Access Compliance Report Public Rights-of-Way (Curb Ramps)

Main Street: MALENA_DR Cross Street: RAINIER_DR Location: SW

ADA ID: RPAT210930121213 Ramp Type: Type 1 - Perpendicular Diagonal Initial Pass/Fail: Pass Overall Compliance: No Severity Score: 20

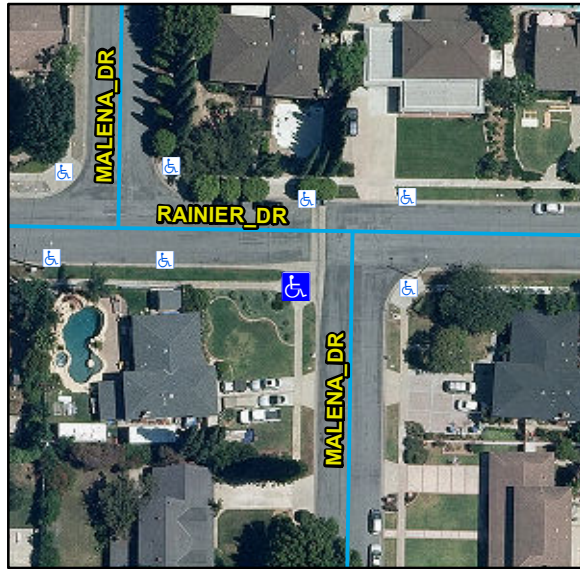
Compliance	Description	Data	Compliance	Description	Data
N/A	Ramp Length (in)	132	N/A	Flare Type LT	
Yes	Ramp Width (in)	54			Sloped
Yes	Ramp Run Slope (%)	7	N/A	Flare Slope LT (%)	4
Yes	Ramp Cross Slope (%)	1.1	N/A	Flare Traversable LT	No
N/A	Landing Present	No	N/A	Flare Type RT	
N/A	Landing Length (in)	N/A			Sloped
No	Landing Width (in)	N/A	N/A	Flare Slope RT (%)	7.1
No	Landing Run Slope (%)	N/A	N/A	Flare Traversable RT	No
No	Landing Cross Slope (%)	N/A	No	DWS Provided	No
N/A	Landing Movement Obstructed?	No	N/A	DWS Contrast	N/A
	Landing Movement Type	N/A	N/A	DWS Length (in)	N/A
N/A	Landing Shared	N/A	N/A	DWS Full Width	N/A
N/A	Clear Space	Yes	N/A	DWS Offset Left (in)	N/A
N/A	Clear Space To Crosswalk (in)	48	N/A	DWS Offset Right (in)	N/A
N/A	Marked Crosswalk 1	No	N/A	Marked Crosswalk 2	No
	Crossing 1 Direction	N		Crossing 2 Direction	E
	Marked Crosswalk 1 Width (in)	N/A		Marked Crosswalk 2 Width (in)	N/A
N/A	Ramp Inside Crosswalk 1	N/A	Yes	Ramp Inside Crosswalk 2	N/A

Crossing 1 Slope (%)	5		Crossing 2 Slope (%)	3.2
	Crossing 1 Cross Slope (%)	0.8		Crossing 2 Cross Slope (%)	0.9
Yes	Gutter Ponding	No	No	Curb Slope	7.6
Yes	Gutter Lip Height (in)	0		Road Run Slope (%)	1.6
Yes	Gutter Run Slope (%)	1.8		Road Cross Slope (%)	1
No	Gutter Cross Slope (%)	3.1			
Yes	Overall Surface Condition: Acceptable		No	Perp Joint Present	No
	Cross Gutter Present?	Yes		Spandrel Present?	Yes
	Replace Cross Gutter?	No		Replace Spandrel?	No

Remove & Replace Curb Ramp With Two New Directional Ramps or Equivalent. Remove & Replace Gutter.
